**RE:   Parcels F & G at the Colony Golf and Bay Club at Pelican Landing  
      ADD2012-00064  
      3rd Submittal**

**EXHIBIT H-2.B.2**  
**SITE PLAN**

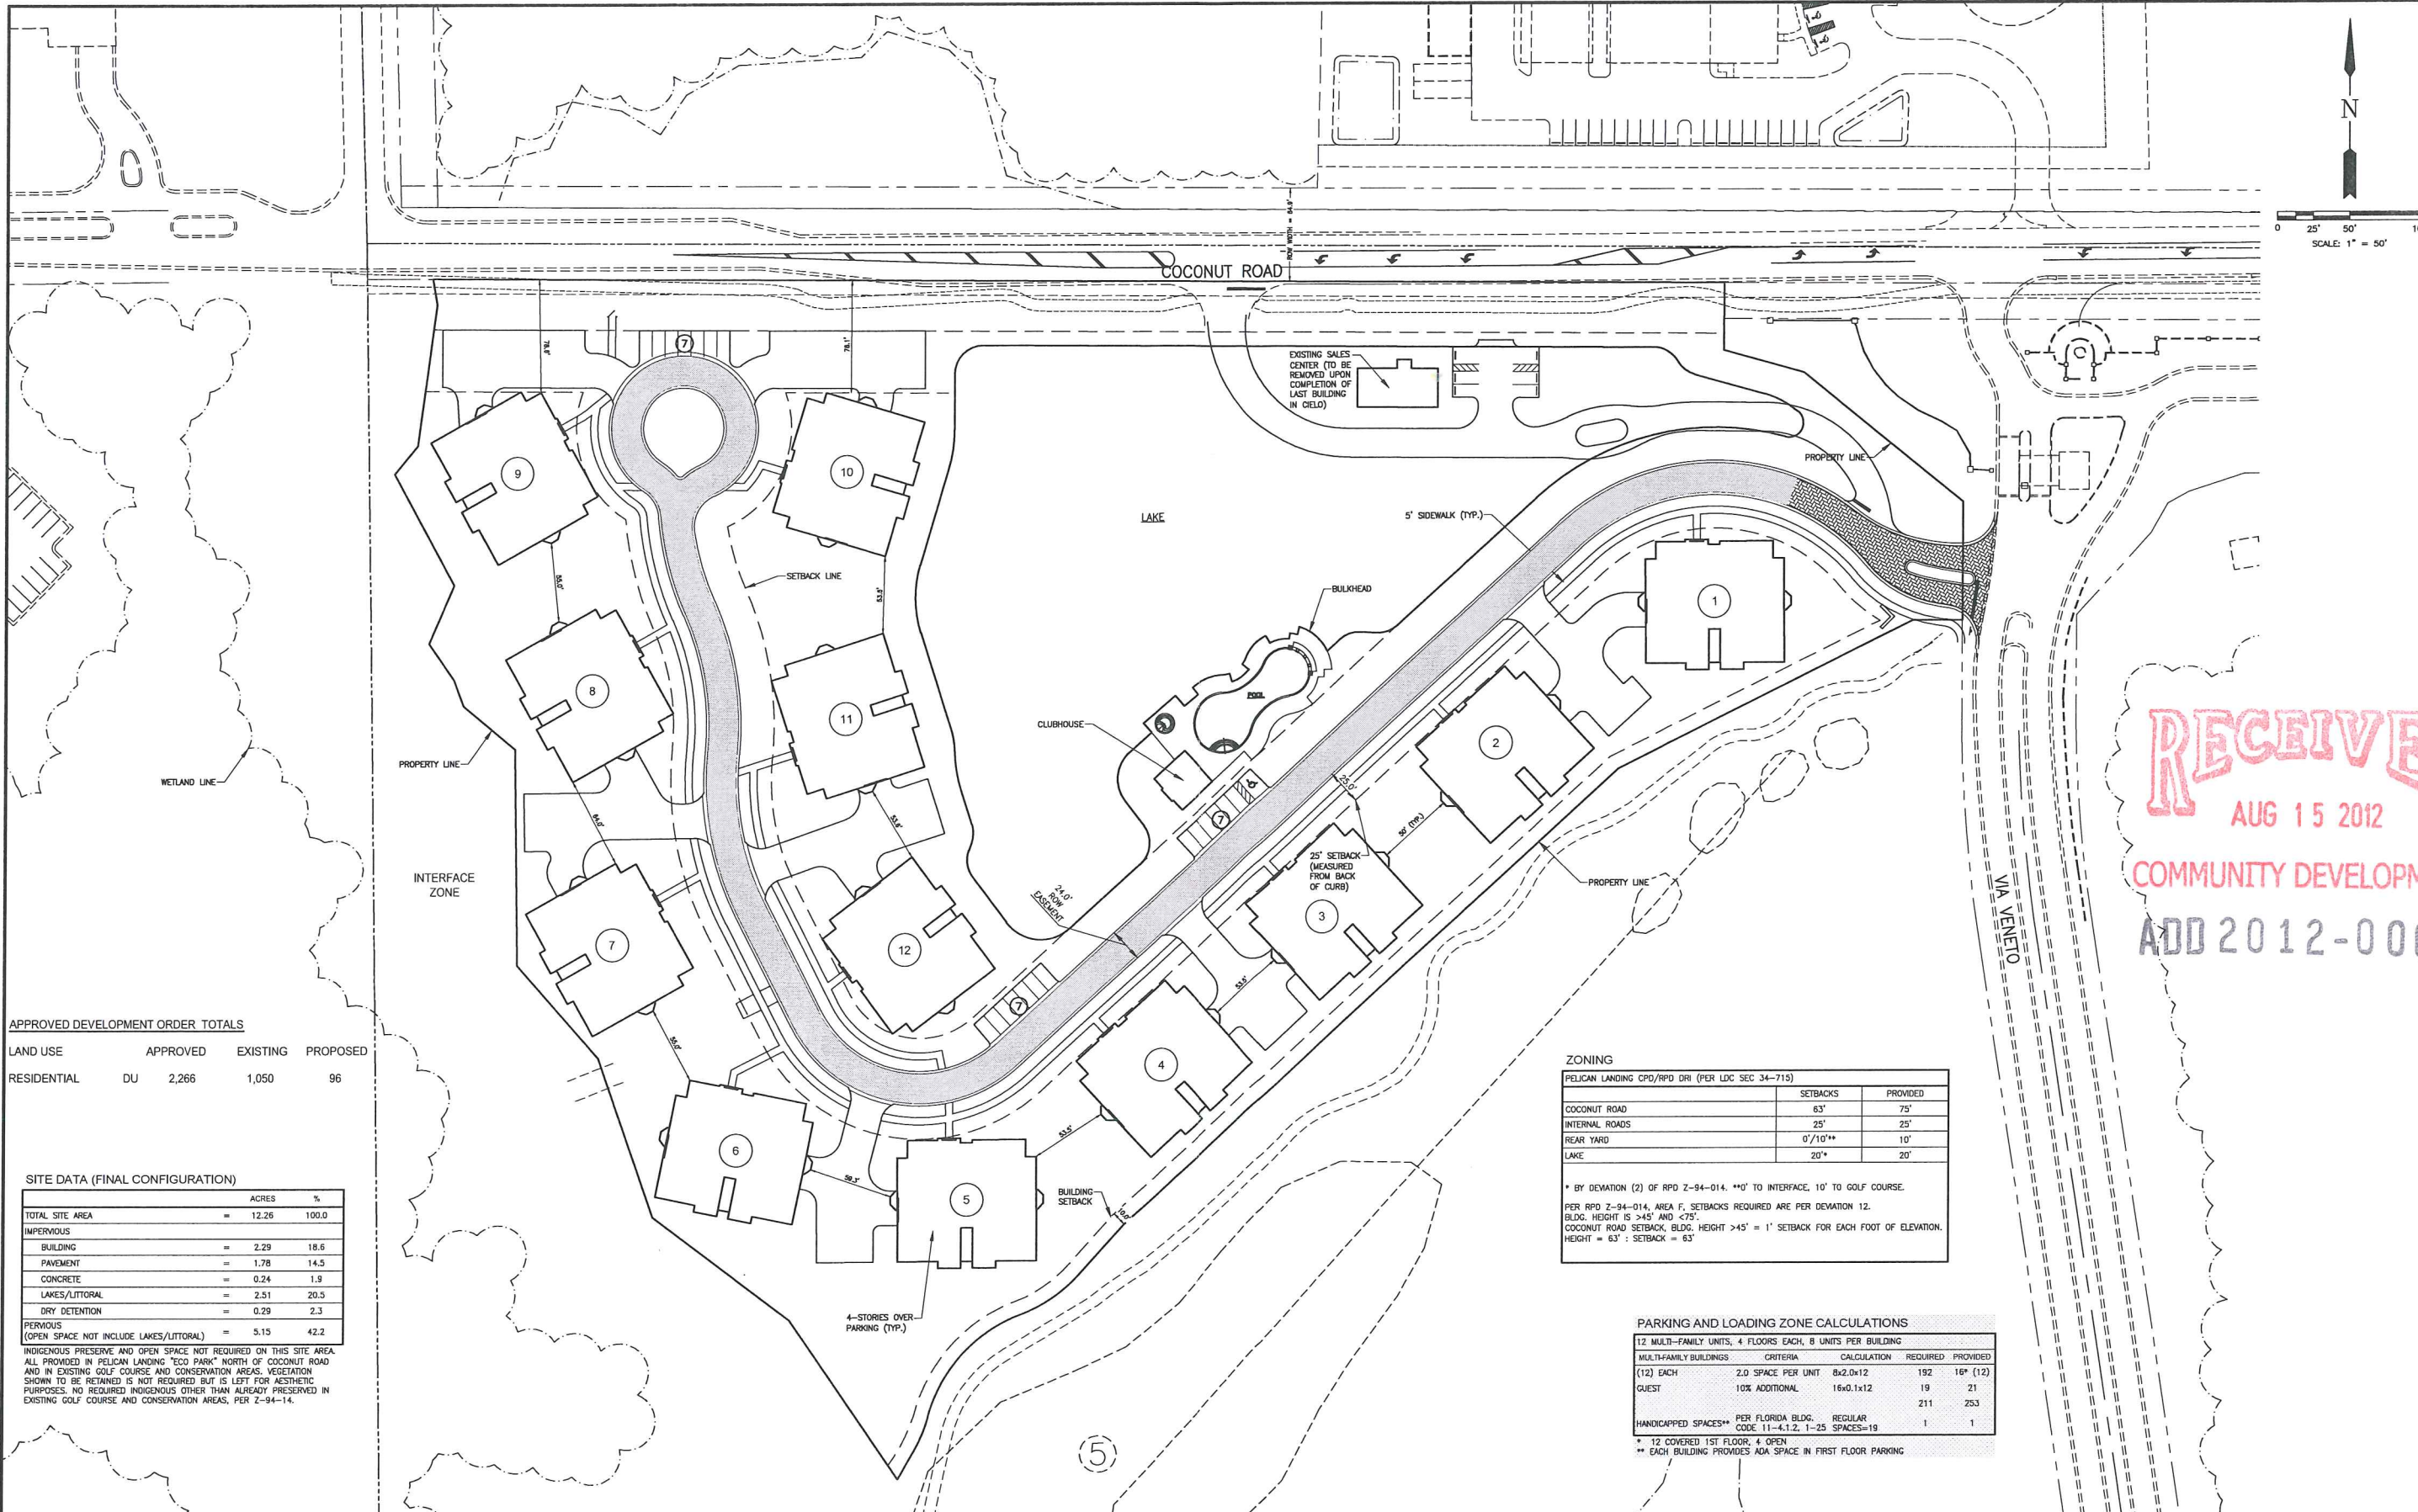
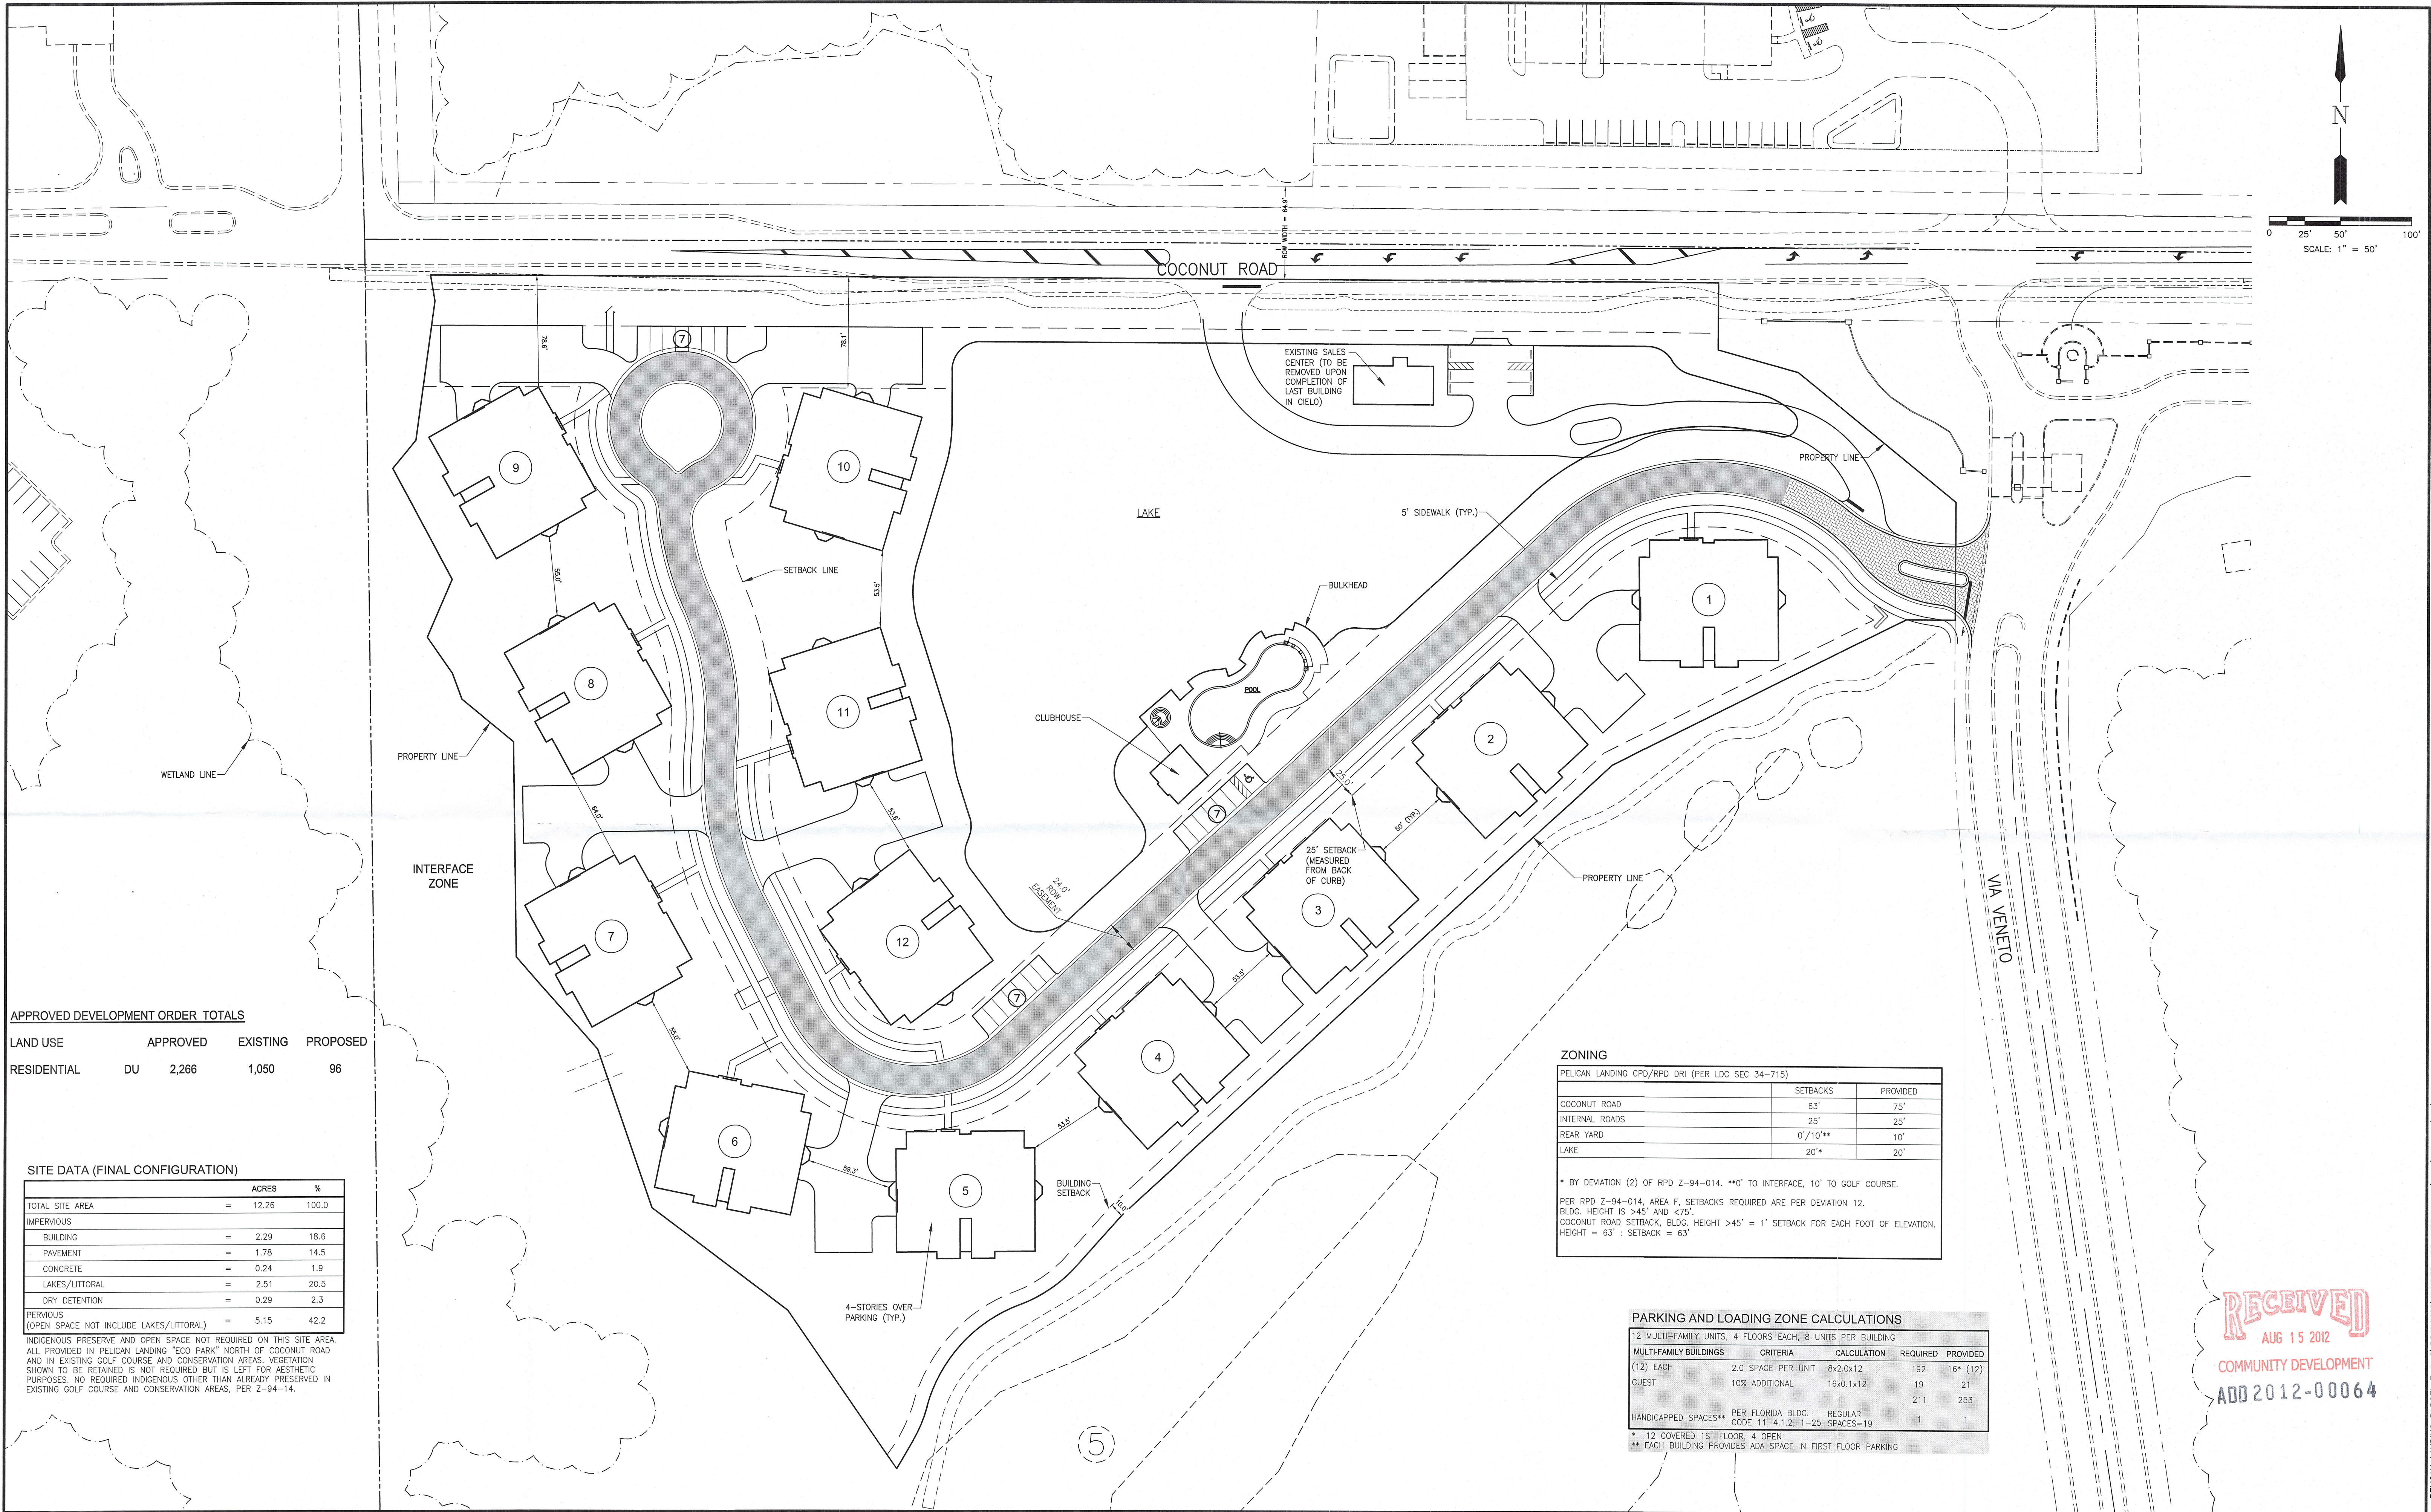
1. The Approved Development Order Totals provided on the MCP state that there are 2,680 residential units existing. Resolution Z-95-061 (Condition 4) limits development of RPD areas B, D, E and F to a maximum of 2, 266 du. Please provide a breakdown demonstrating compliance with Condition 4 of Z-95-061. Please also specify whether the units proposed in this application are included in the calculation.

2. The line types are still unclear. Is the property line a solid bold-line or a broken-line?

3. The sales center, parking and access drive need to be shown on the Final Plan approval and labeled "To be removed" (otherwise, a DO with these structures cannot be issued). I apologize if this was unclear in staff's first set of comments. Can the sales center, parking and access drive be removed once the first condo building is constructed and a CO issued?

Exactly when will the sales center be removed and the lake completed? Can the sales center be moved into one of the proposed buildings – such as building 1 or the amenities center?

4. Please demonstrate that the minimum required 63' setback (see Deviation 12, Z-94-014) is provided from buildings 9 and 10 to the Pelican Landing perimeter property line. Please show on the MCP the right-of-way width to the edge of curb.

5. Please demonstrate the minimum required setbacks from the internal road right-of-way and for the rear setback. It does not appear that a 20' road right-of-way setback is provided – the setback must be measured from the right-of way or easement.

6. Please demonstrate the minimum required setbacks for the rear setback. How was the minimum 0' rear setback determined?

7. Except for parking spaces for amenities, on-street parking that backs out into road right-of-ways cannot be approved. Please revise.

**Response: The Site Plan has been revised to clarify the allowed, existing and proposed number of dwelling units.**

**Response: It's the solid line (look under the words "Coconut Road"). The broken line is a line that should be turned off as it's only used for the ACAD layout. We have revised accordingly and call out the property line in several places.**

**Response: The Site Plan has been revised to add back in the sales center, sales center parking and access drive with a note "to be removed". We are modifying the DO plans to show their removal as a phase, last phase to be removed with last building construction.**

**The center will be removed once the last building is sold/started construction. The lake will be completed then too. It needs to be out there to separate residents/construction/visitors.**

**Response: The Site Plan has been revised to show the distance of the buildings from the perimeter property line and the right-of-way width.**

**Response: The back of curb is the easement line, per previously approved deviation 8. It's actually 25 ft setback and we'll depict that and the easement line. The plan has been revised to dimension the 25ft.**

**Response: 0' is for interface line. It's 10 ft against the golf course. The Zoning table on the Site Plan has been revised to clarify these setbacks.**

**Response: Per previously approved deviation 2 of the RPD, this allows back out.**
